Product Change Notification - SYST-13SYHI351

Date:	13 Jul 2011
Product Category:	8-bit Microcontrollers
Device Family:	
Notification subject:	ERRATA - PIC24FJ256GB110 Family Silicon/Data Sheet Errata
Notification text:	<p>SYST-13SYHI351</p> <p>Microchip has released a new DeviceDoc for the PIC24FJ256GB110 Family Silicon/Data Sheet Errata of devices. If you are using one of these devices please read the document located at PIC24FJ256GB110 Family Silicon/Data Sheet Errata.</p>
Attachment(s):	PIC24FJ256GB110 Family Silicon/Data Sheet Errata

PIC24FJ256GB110 Family Silicon Errata and Data Sheet Clarification

The following typographic corrections and clarifications are to be noted for the latest version of the device data sheet (DS39897C):

FIGURE 2-3 FREQUENCY vs. ESR PERFORMANCE FOR SUGGESTED VCAP

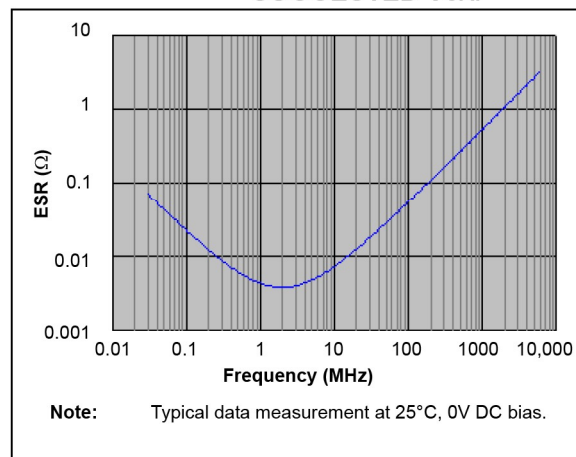
Section 2.4 Voltage Regulator Pins (ENVREG/DISVREG and VCAP/VDDCORE) has been replaced with a new and more detailed section. The entire text follows:

When the regulator is enabled, a low-ESR ($< 5\Omega$) capacitor is required on the VCAP/VDDCORE pin to stabilize the voltage regulator output voltage. The VCAP/VDDCORE pin must not be connected to VDD and must use a capacitor of $10\ \mu\text{F}$ connected to ground. The type can be ceramic or tantalum. Suitable examples of capacitors are shown in **Table 2-1**. Capacitors with equivalent specifications can be used.

Designers may use **Figure 2-3** to evaluate ESR equivalence of candidate devices.

FIGURE 2-4 DC BIAS VOLTAGE vs. CAPACITANCE CHARACTERISTICS

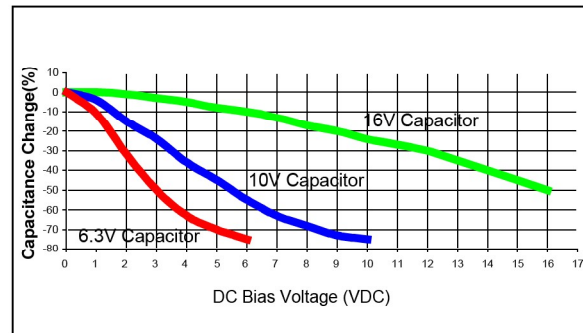
A typical DC bias voltage vs. capacitance graph for 16V, 10V and 6.3V rated capacitors is shown in Figure 2-4.

When selecting a ceramic capacitor to be used with the internal voltage regulator, it is suggested to select a high-voltage rating, so that the operating voltage is a small percentage of the maximum rated capacitor voltage. For example, choose a ceramic capacitor rated at 16V for the 2.5V core voltage. Suggested capacitors are shown in Table 2-1.

FIGURE 29-1: PIC24FJ256GB110 FAMILY VOLTAGE-FREQUENCY GRAPH (INDUSTRIAL)

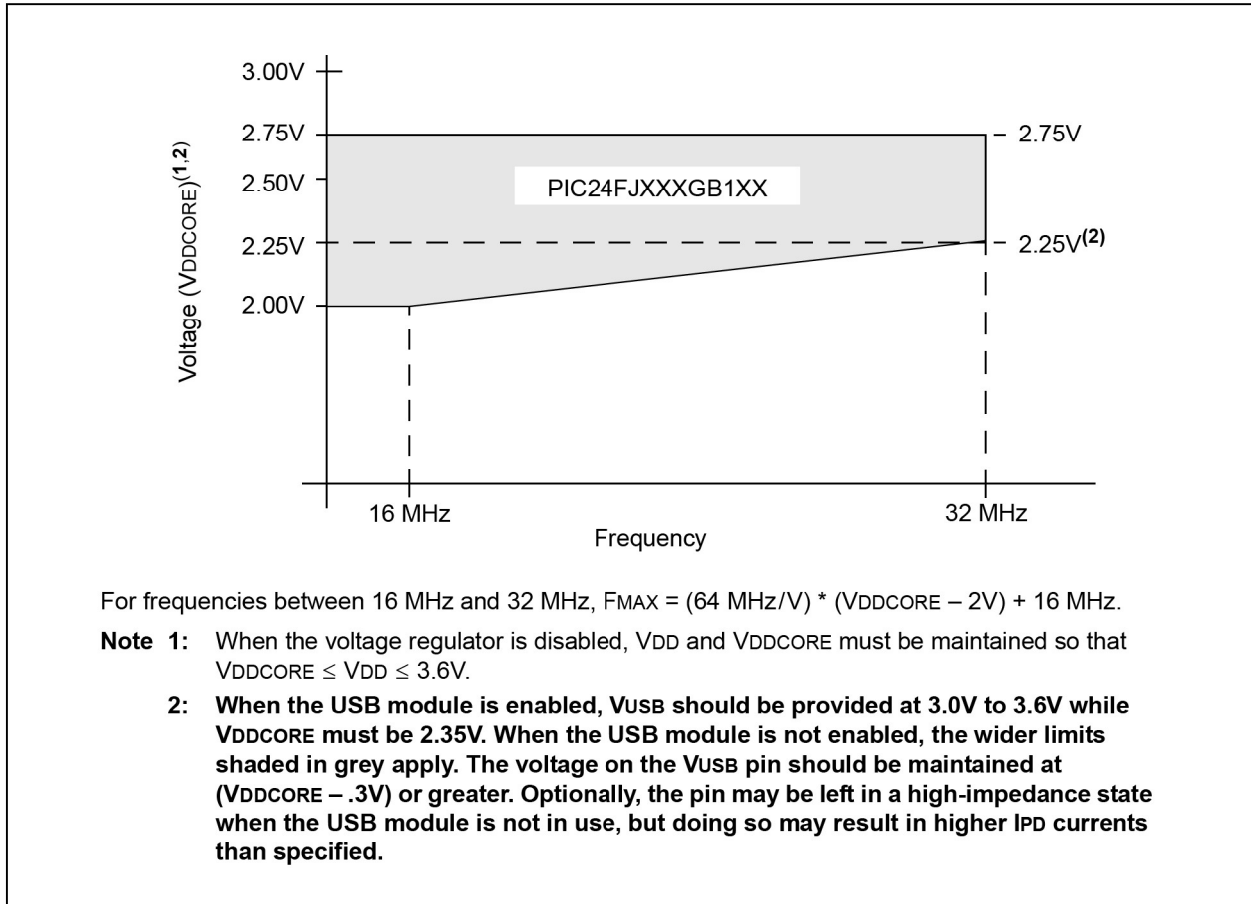
Figure 29-1 ("PIC24FJ256GB110 Family Voltage-Frequency Graph") is amended by adding an additional footnote. The updated figure is shown below (changes in **bold**; bold in original removed for clarity).
